Job:
RESIDENTIAL FLAT
BUILDING: - 1147, 1149
PACIFIC HWY & 2 BOBBIN
HEAD ROAD PYMBLE

BASEMENT LEVEL 1

SK04A

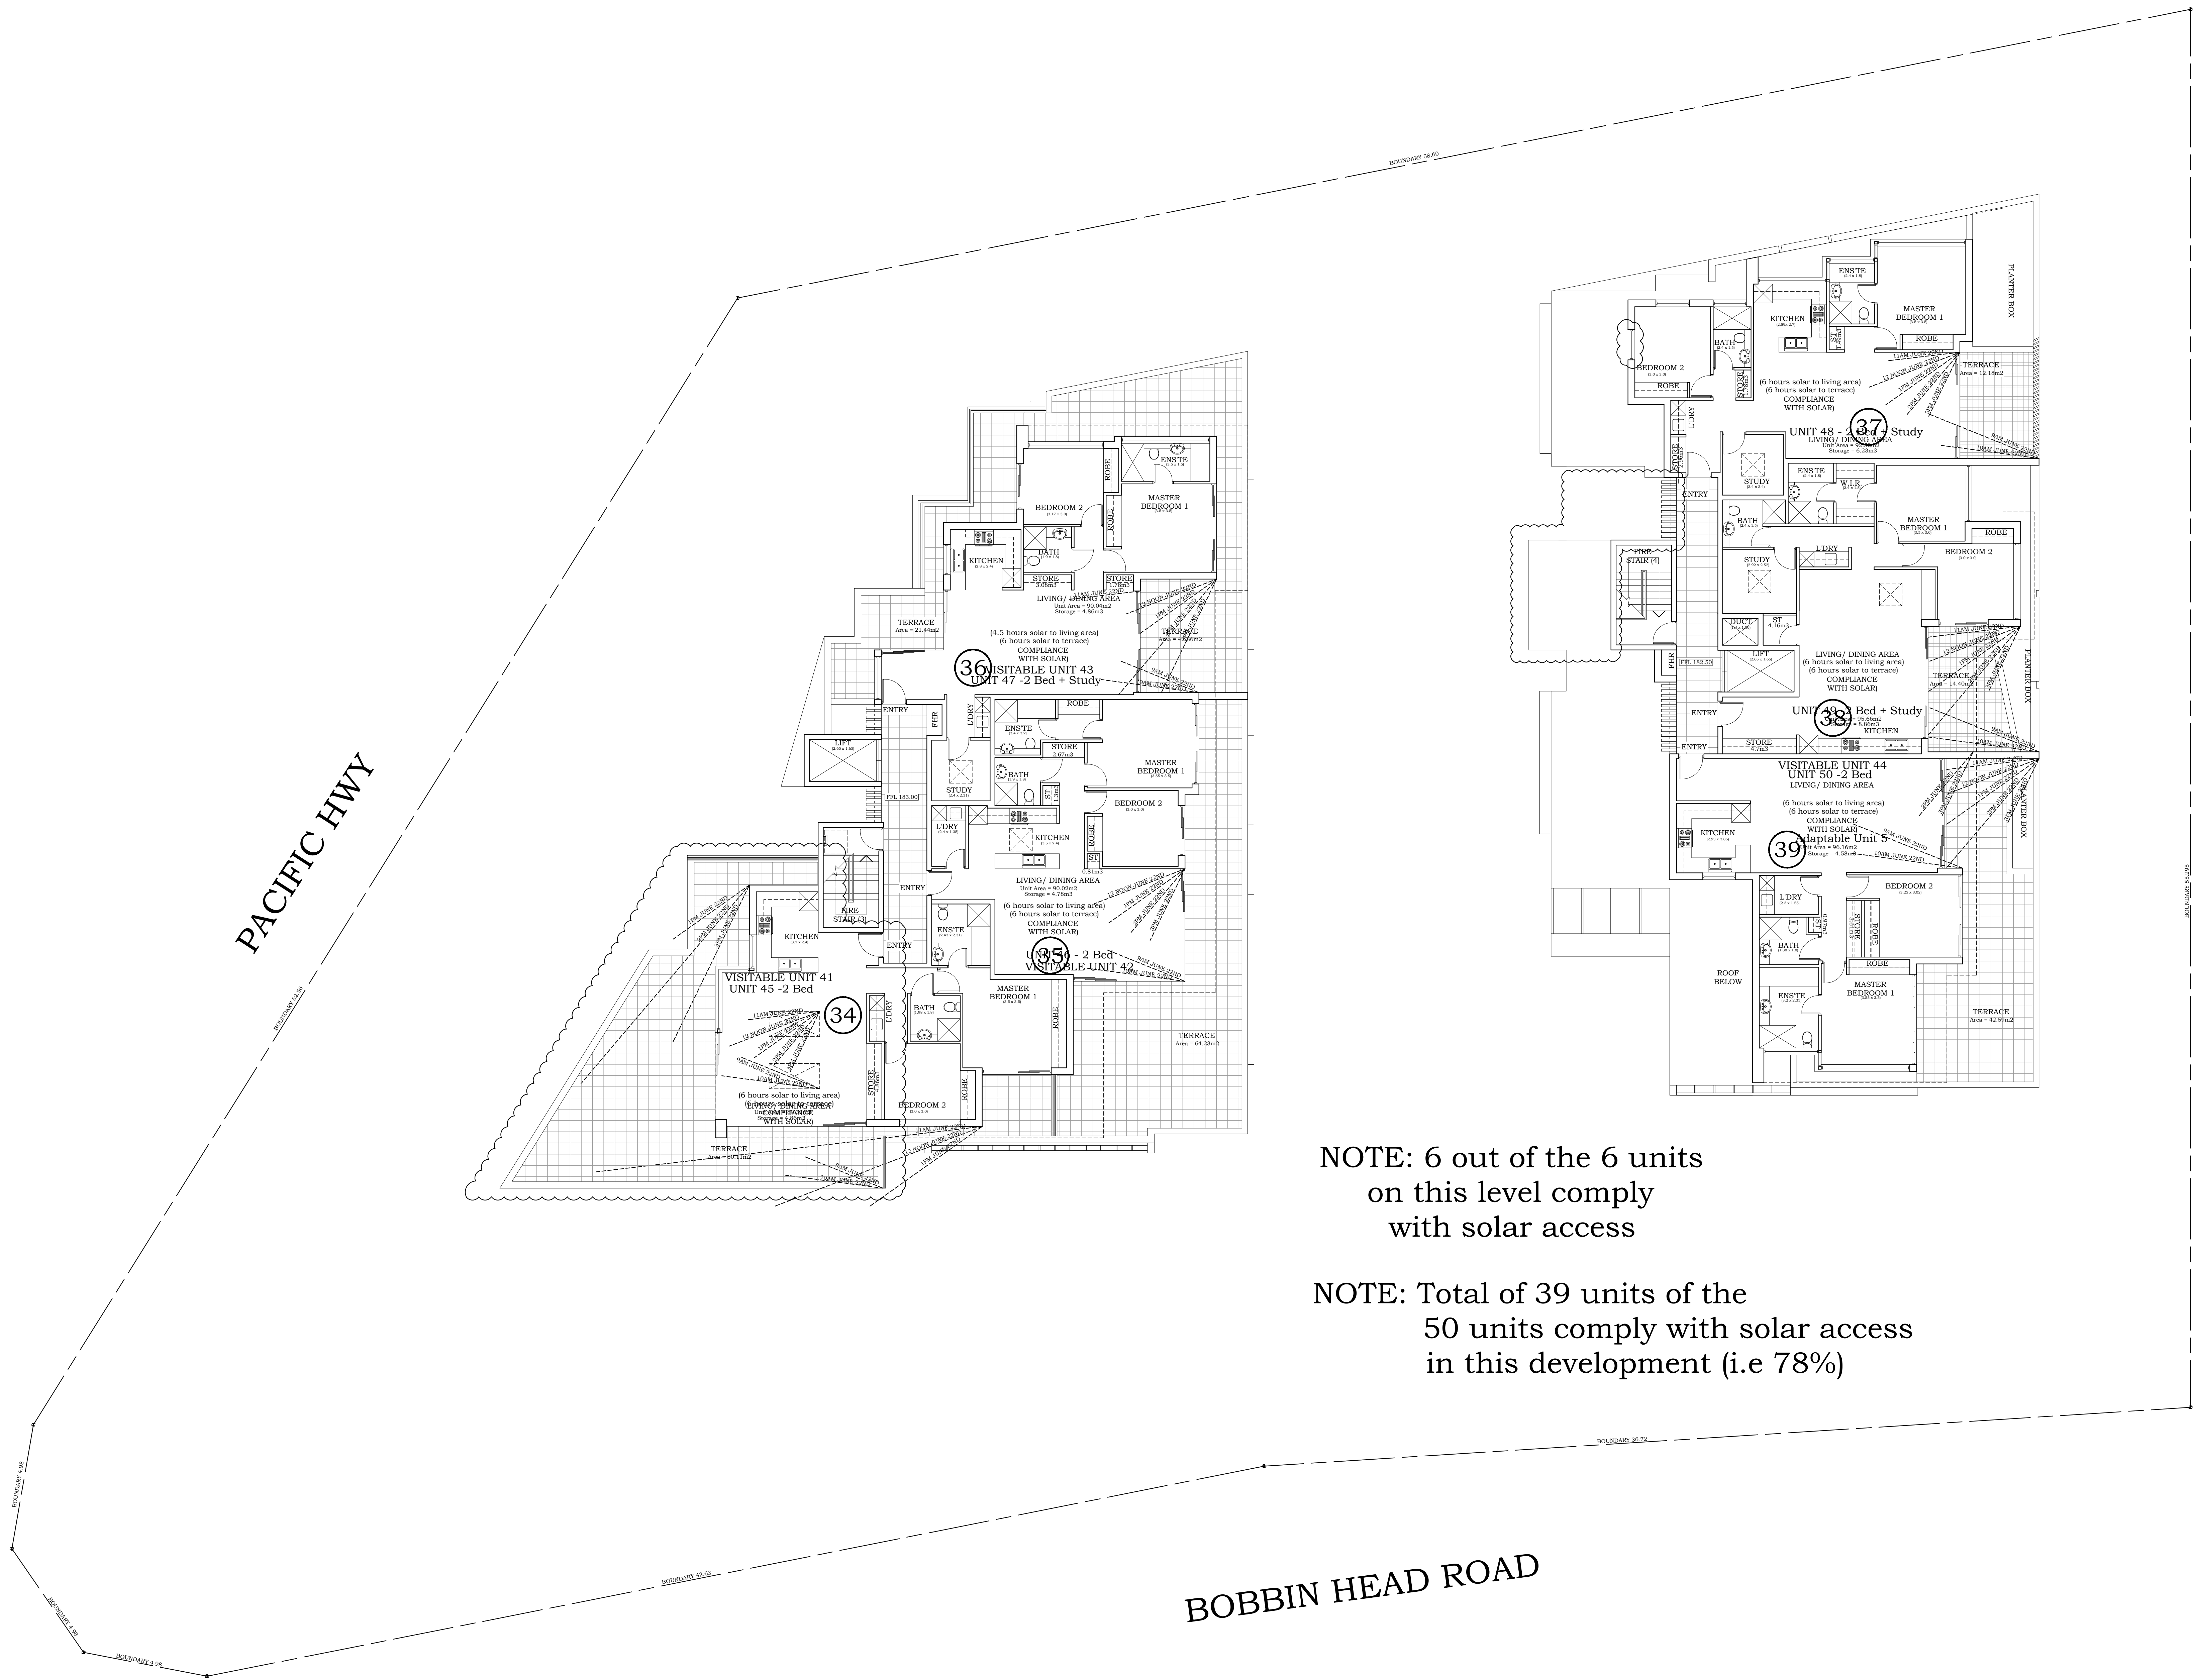
REV	AMENDMENTS	DATE
A	- layout of terrace to Unit 45 has been amended to reflect changes made below.	30.05.11

Drawing title:
CROSS VENTILATION
COMPLIANCE
DIAGRAMS

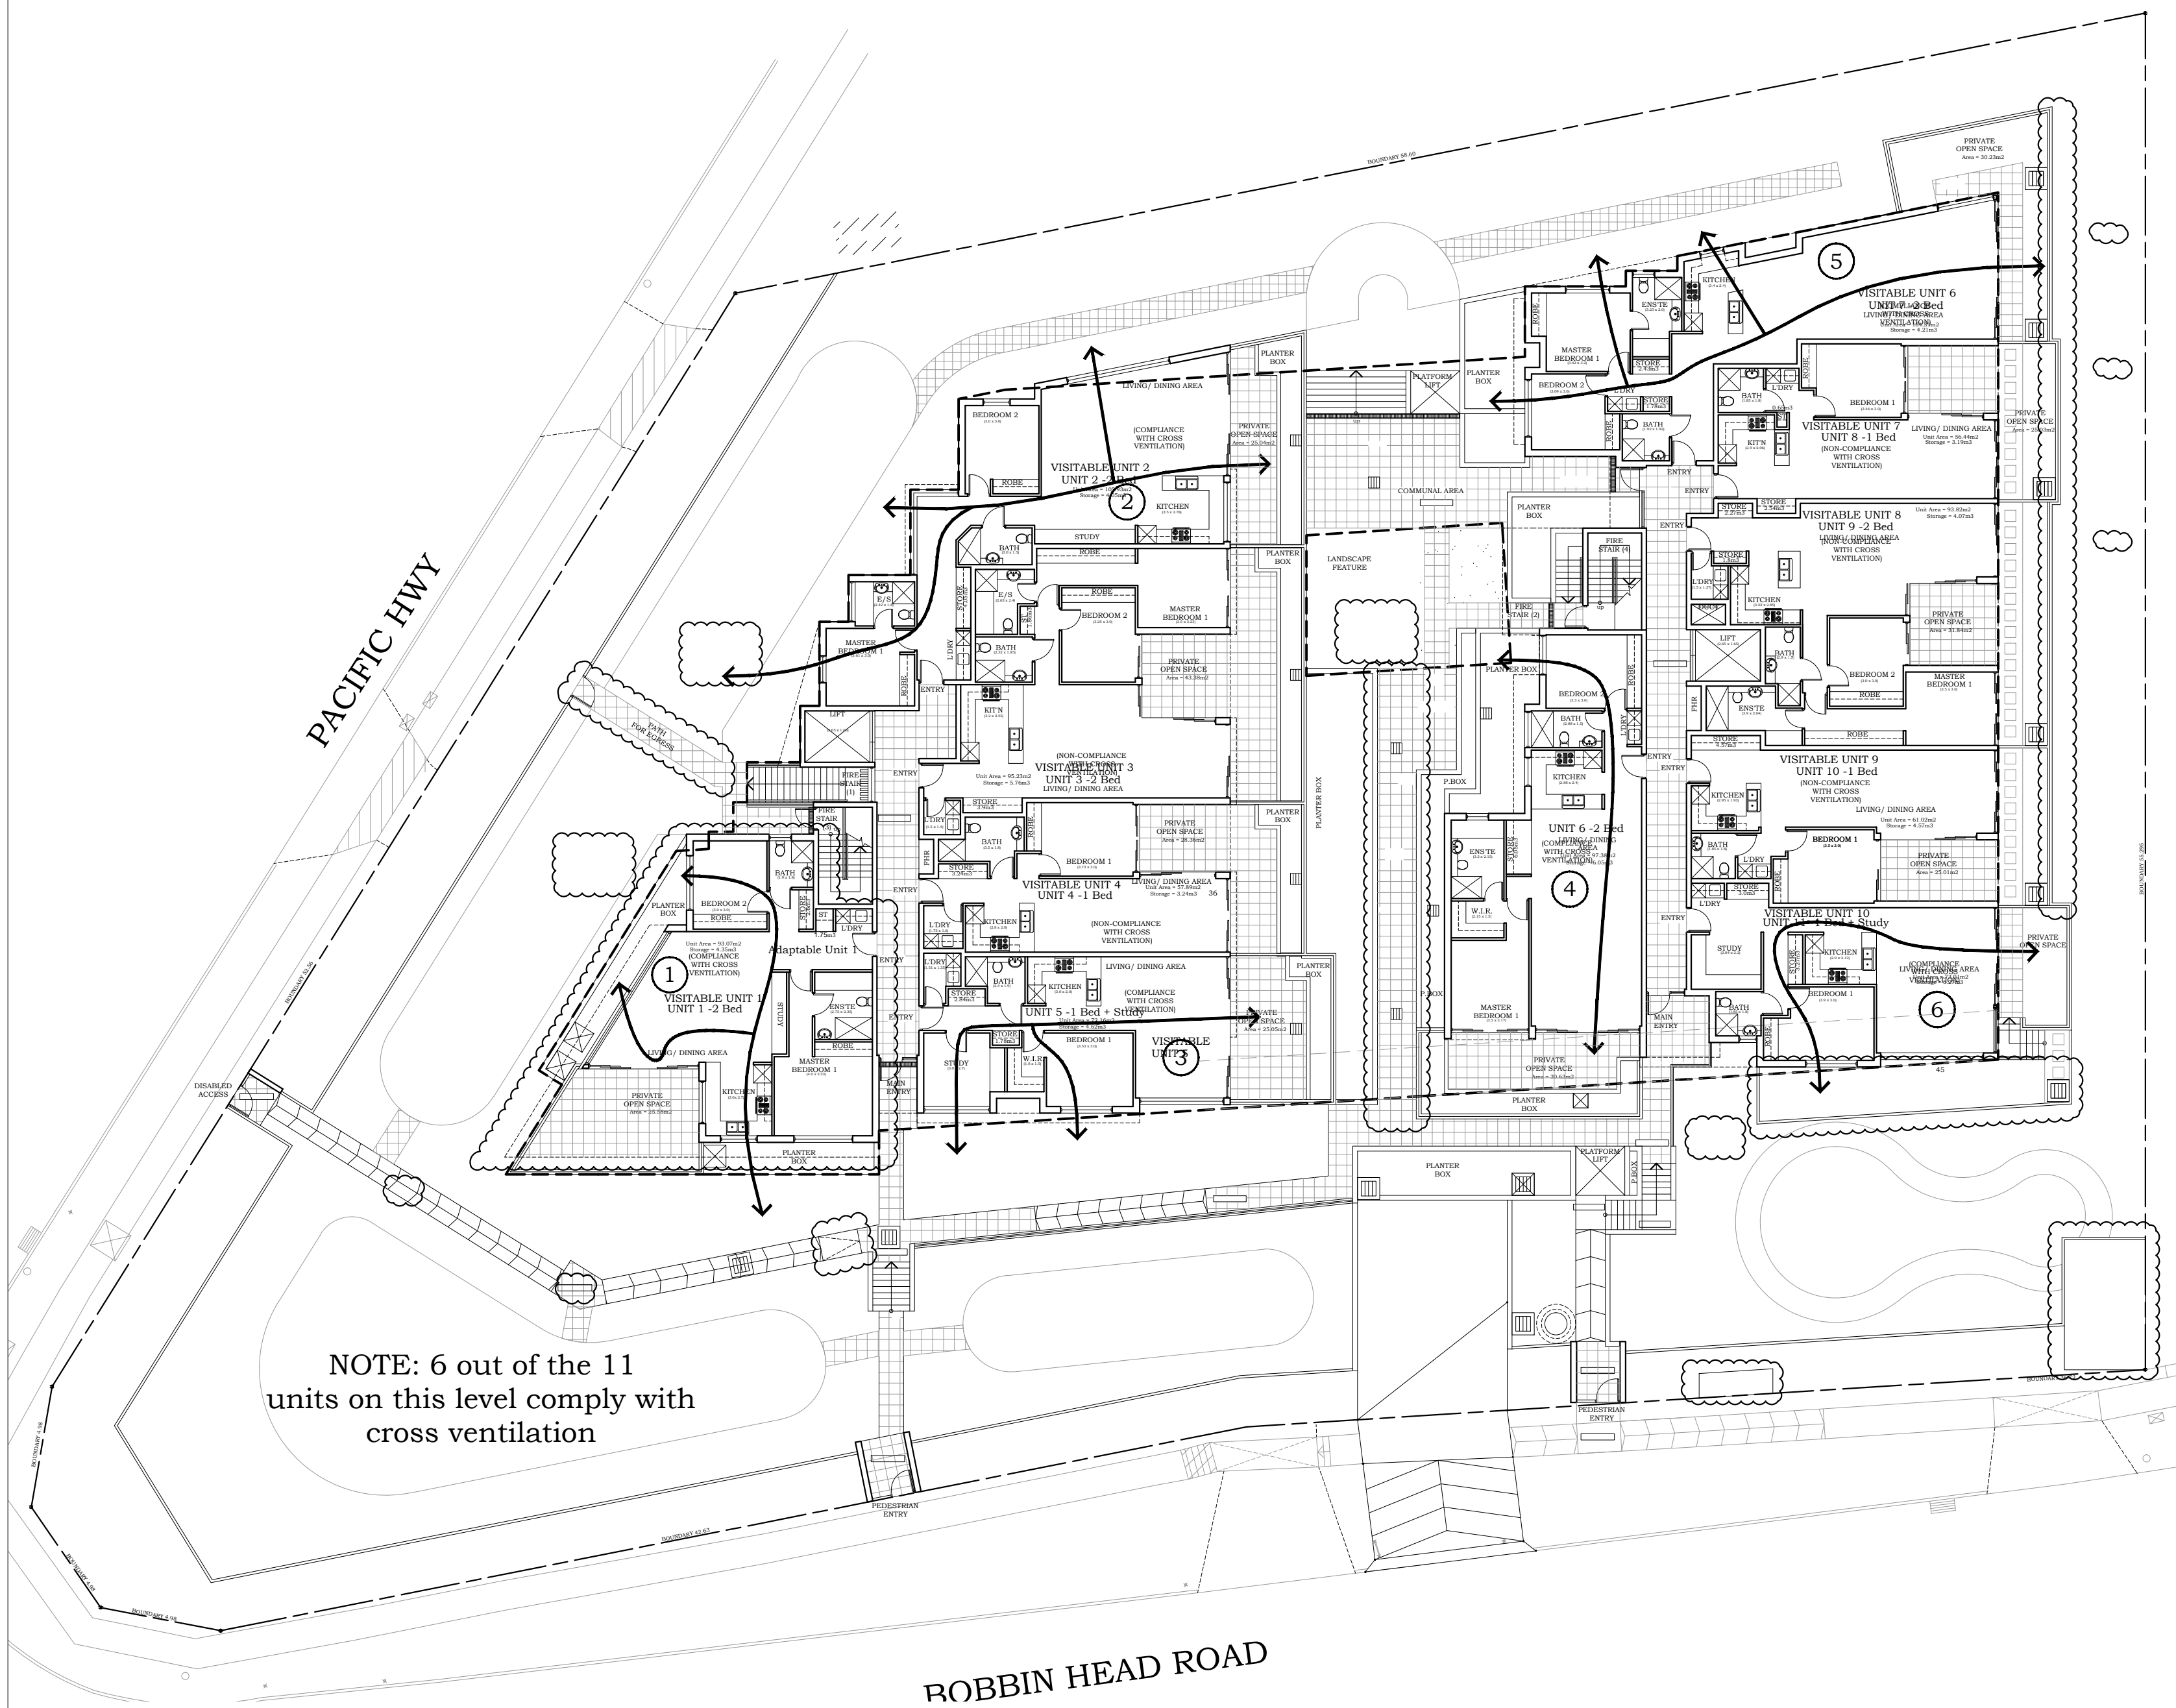
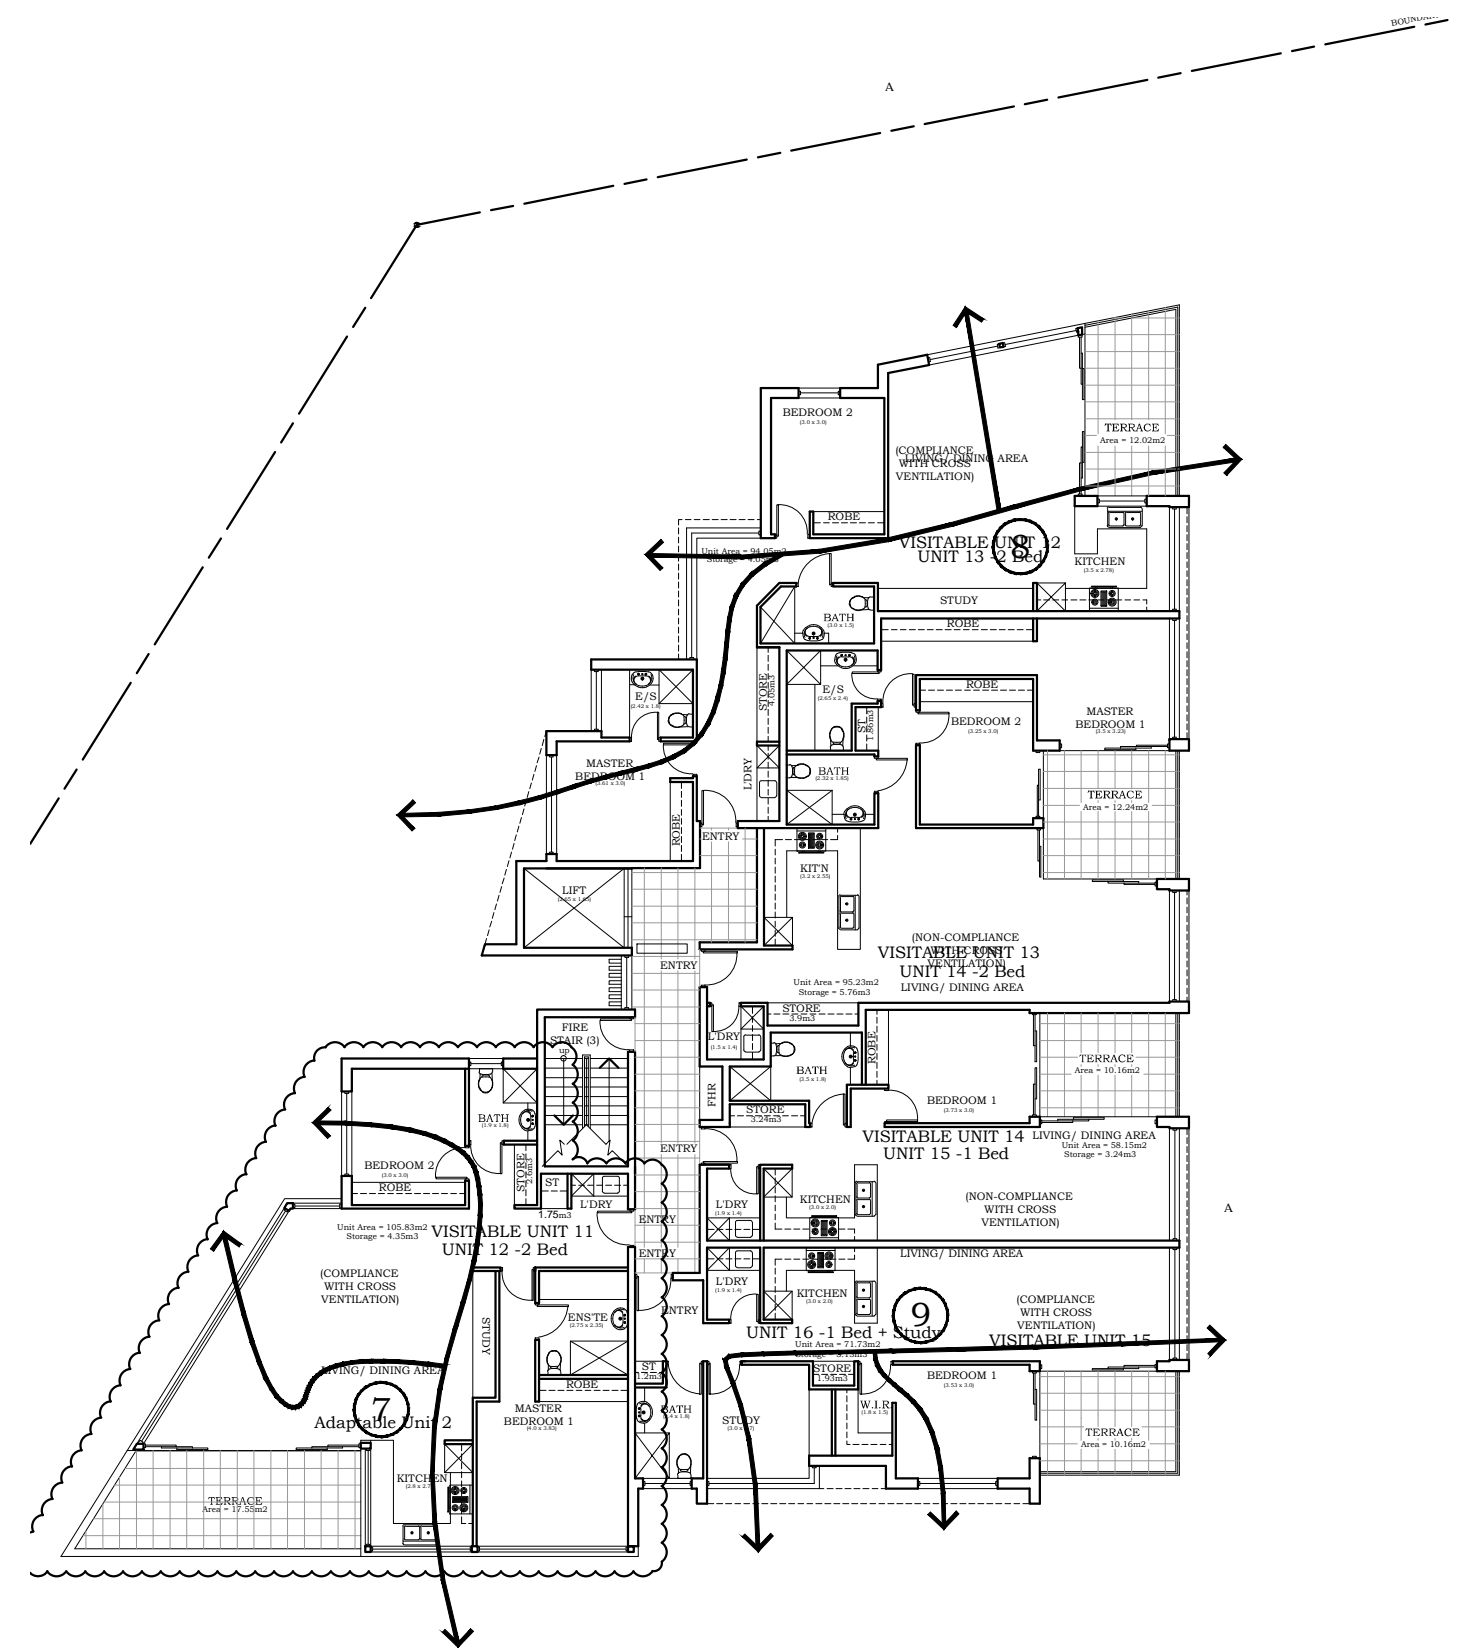
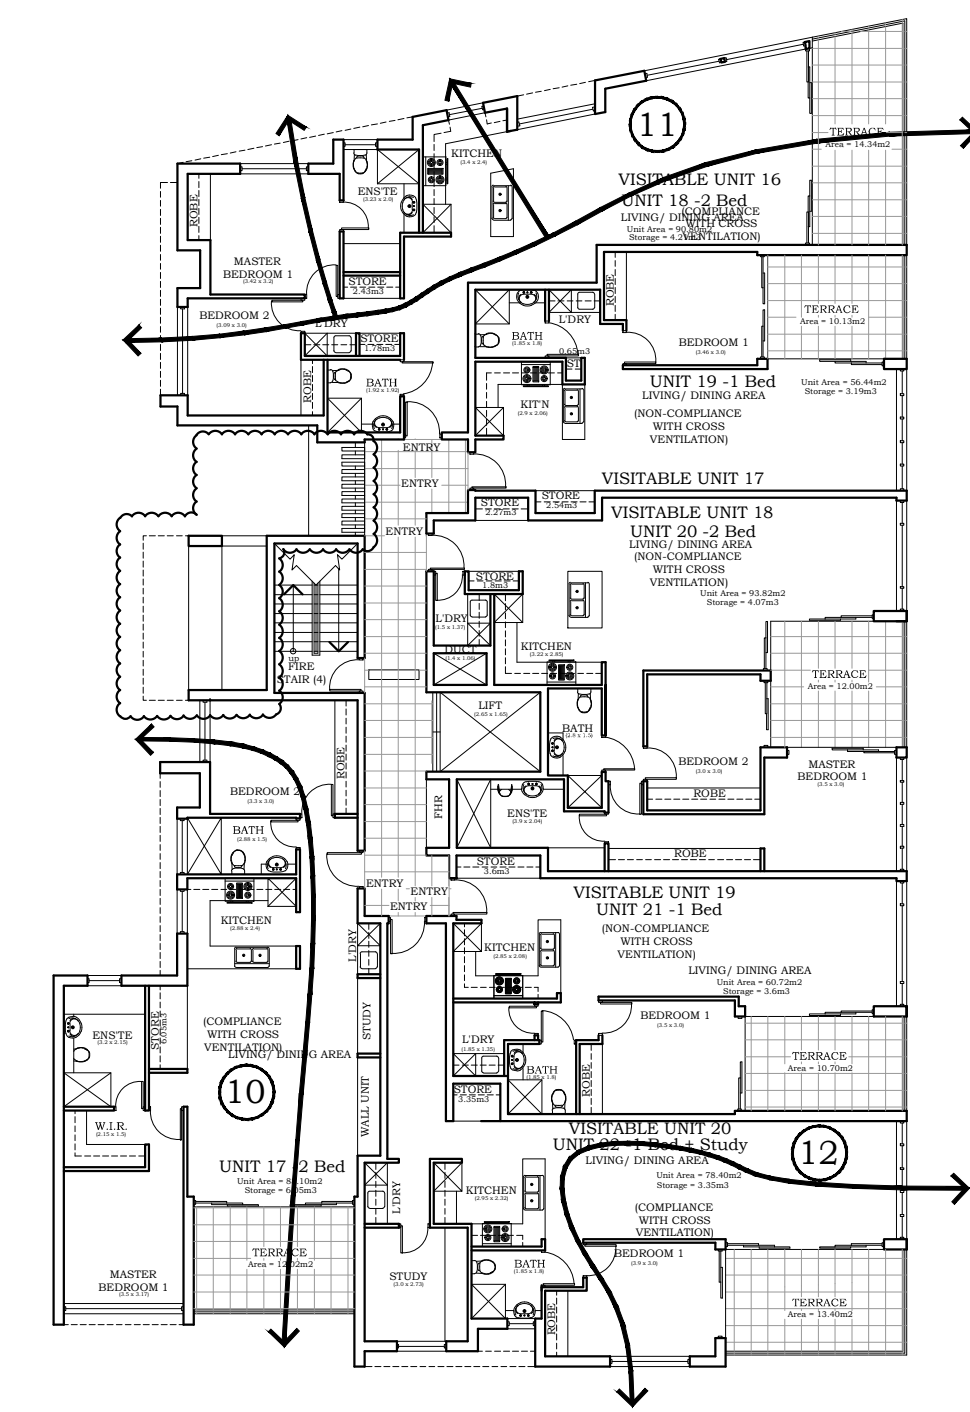
REV	AMENDMENTS	DATE
A	<ul style="list-style-type: none">- the private courtyards adjacent to the northern boundary have been setback further from the northern boundary.- egress path has been added adjacent to fire stair 3- egress path has been amended adjacent to fire stair 2 & 4 so that more doors & windows are 6m away from the egress path- pedestrian path/ramp adjacent to disabled entry now complies with the Australian standards- substation has been moved so that it now lines up with the street frontage.- Courtyard of unit 11 has increased in size.- Paving has been added to the courtyards of unit 7 & 11.- Stepping stones have been removed from the private courtyard of unit 1	30.05.11
